ITEM: 908 Rex Street Landmark/ Historic Preservation Fund
Grant/Alteration Certificate Request

REQUEST: The applicant requests to Landmark the structure at 908
Rex Street and a request for a Preservation and
Restoration Grant and Alteration Certificate at 908 Rex
Street.

908 Rex Street - Proposed

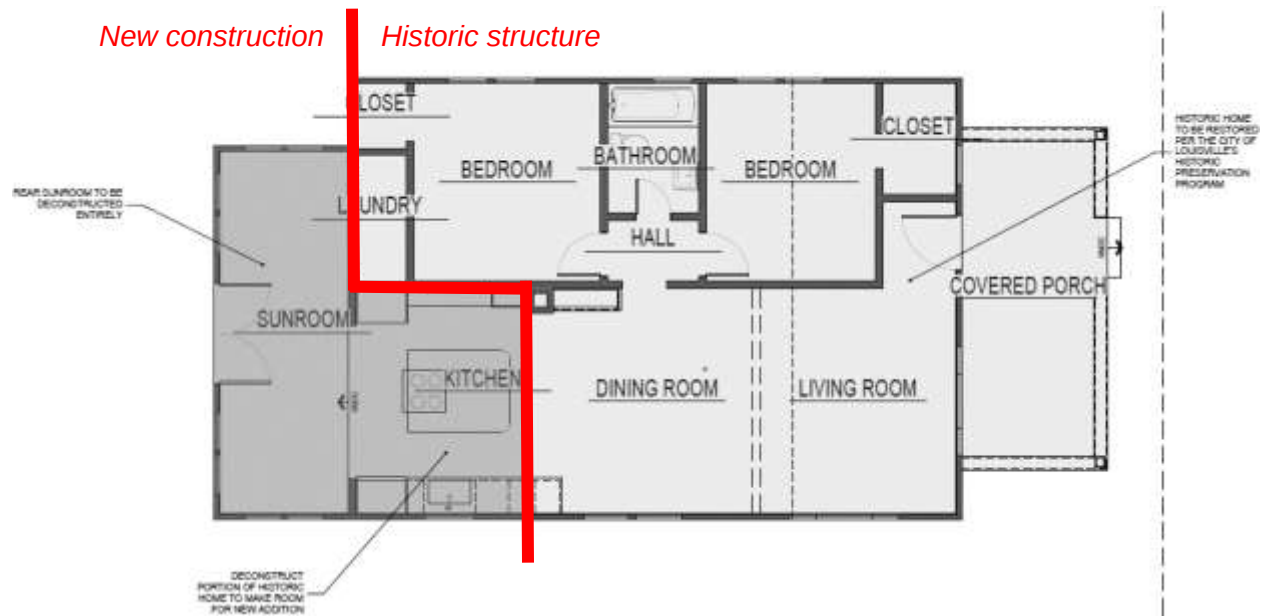
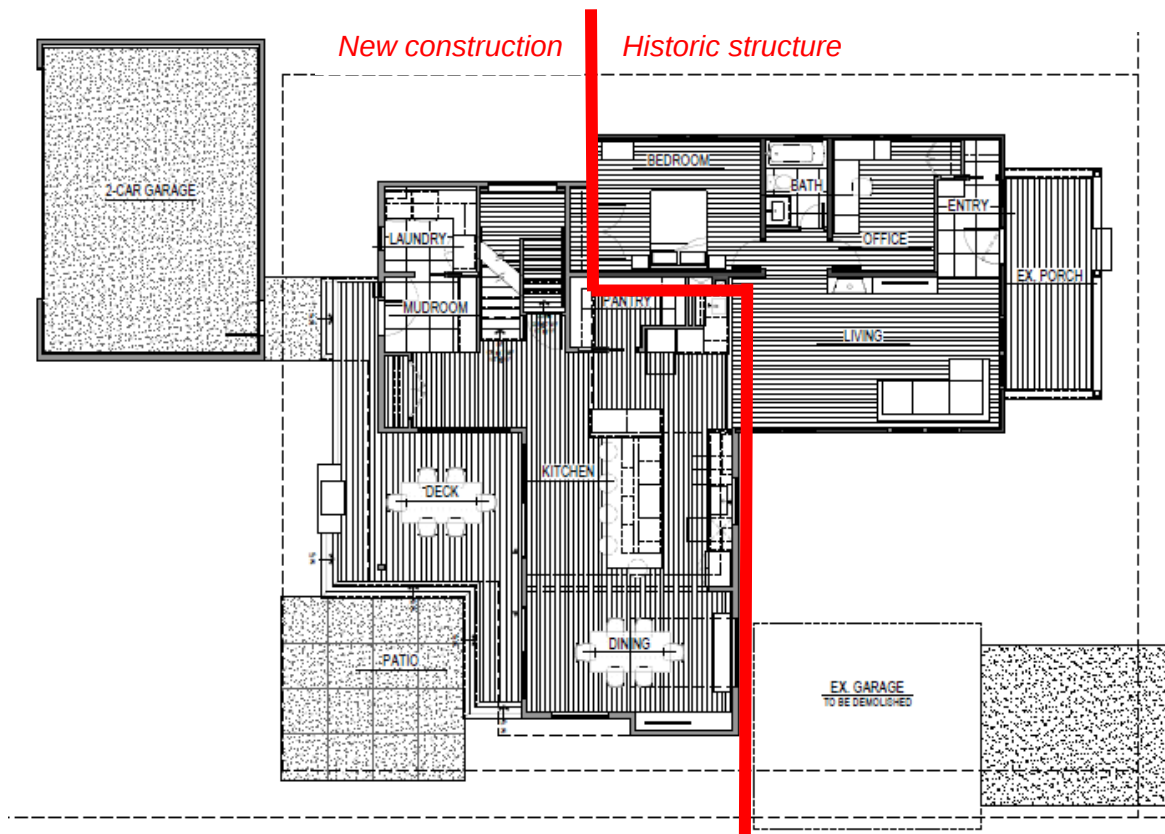
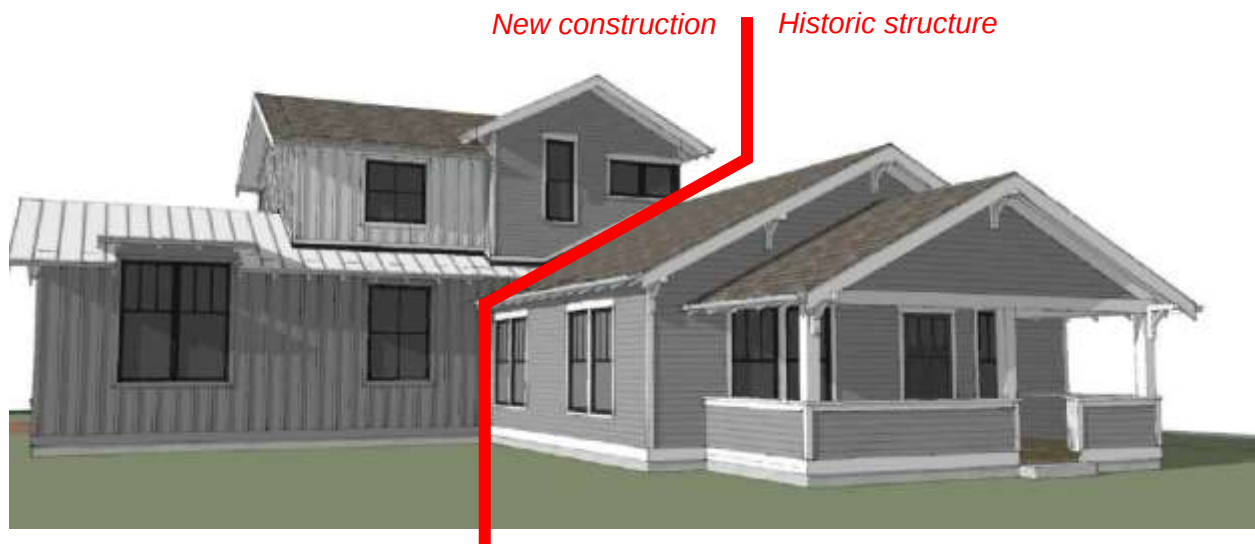
Criteria and Standards	Meets Criteria?	Evaluation
<i>1. The effect upon the general historical and architectural character of the structure and property.</i>	Yes	The proposed work, including removing replacement windows and gutters and replacing with period appropriate pieces, refurbishing the front door, and repairing the original siding will enhance the historic architectural character of the structure.
<i>2. The architectural style, arrangement, texture, and material used on the existing and proposed structures and their relation and compatibility with other structures.</i>	Yes	The addition is clearly distinguishable from the original structure due to changes in material, wall plane, and fenestration.
<i>3. The size of the structure, its setbacks, its site, location, and the appropriateness thereof, when compared to existing structures and the site.</i>	Yes	The addition will substantially add to the size of the house, however its proposed location is secondary to the original structure allowing the original structure to retain its historic form.

<i>8. j. New additions and adjacent or related new construction shall be undertaken in such a manner that if removed in the future, the essential form and integrity of the historic property and its environment would be unimpaired.</i>	Yes	The proposed rear addition will result in the removal of a prior rear addition to the original house. The construction of the new addition will also remove a portion of the original house on the southeast corner. The essential form and integrity of the historic property will be retained.
